Enclosure 1, Attachment 1 to MFN 07-485

**Response to Portion of NRC Request for
Additional Information Letter No. 88
Related to ESBWR Design Certification Application
ESBWR Probabilistic Risk Assessment
RAI Numbers 19.1-96, 19.1-102 through 19.1-108
and 19.1-110 through 19.1-115**

Case 1: Loss of SDC @ 8 hours, 1 SRV, FAPCS/LPCI

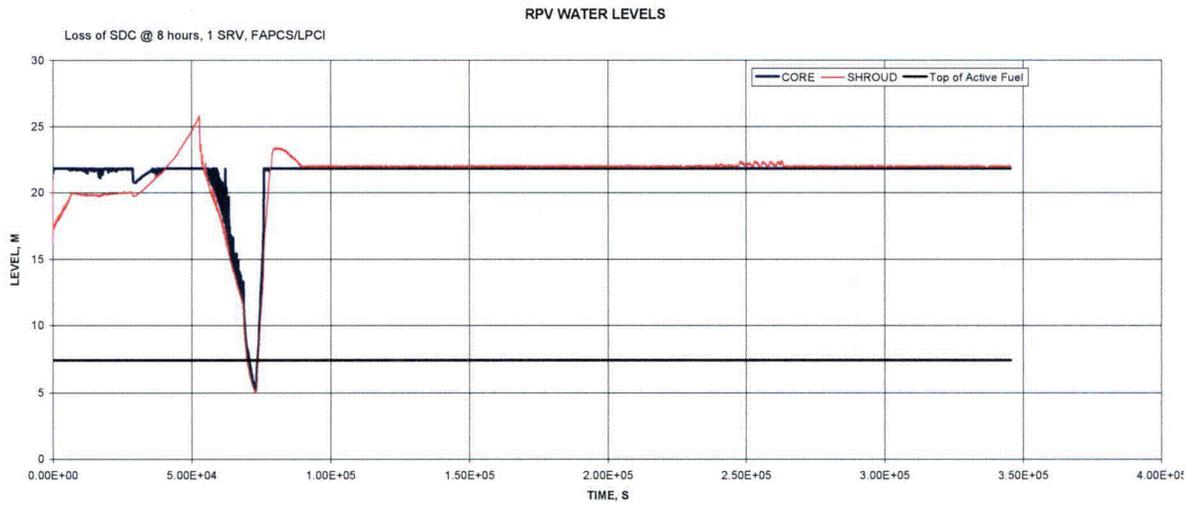
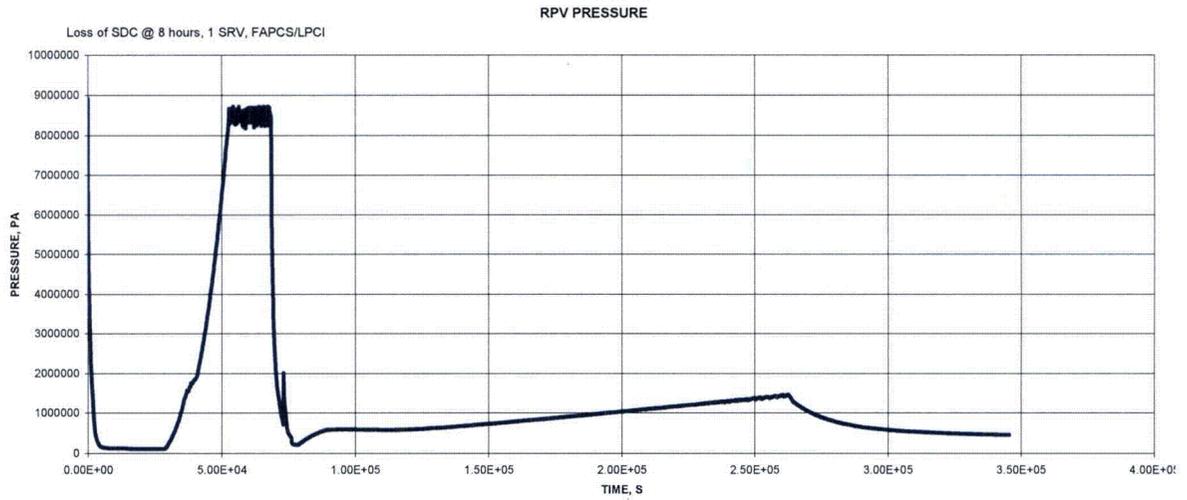
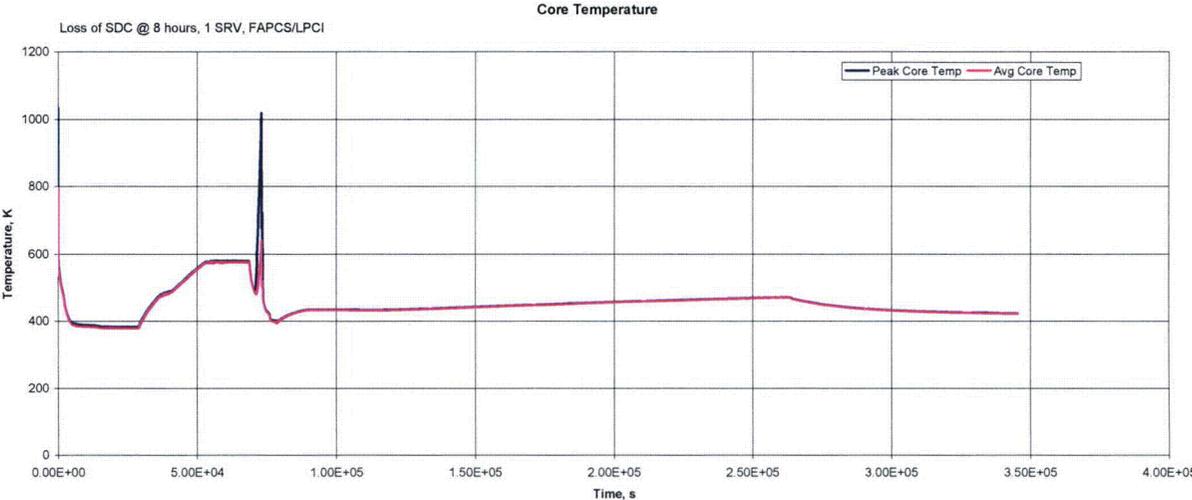
To address thermal-hydraulic uncertainty regarding shutdown success criteria, please provide additional information (e.g., summary and results of calculations) that justifies short term and long term core cooling using (1) 2 SRVs, (2), 2 out of 8 lines of GDCS, (3) 2 out of 3 GDCS pools, (4) the opening of at least one equalizing line, and (5) the opening of 4 depressurization valves (DPVs) during Mode 5 when the reactor vessel head is on.

The safety function of 2 SRVs in the Shutdown PRA is to depressurize or maintain depressurization of the reactor pressure vessel and to support low pressure injection using active systems. MAAP analysis indicates that 1 SRV is sufficient to depressurize the RPV to allow low pressure injection, using the FAPCS/LPCI Mode after a loss of SDC event occurring at the beginning of Mode 5 as shown in Case 1.
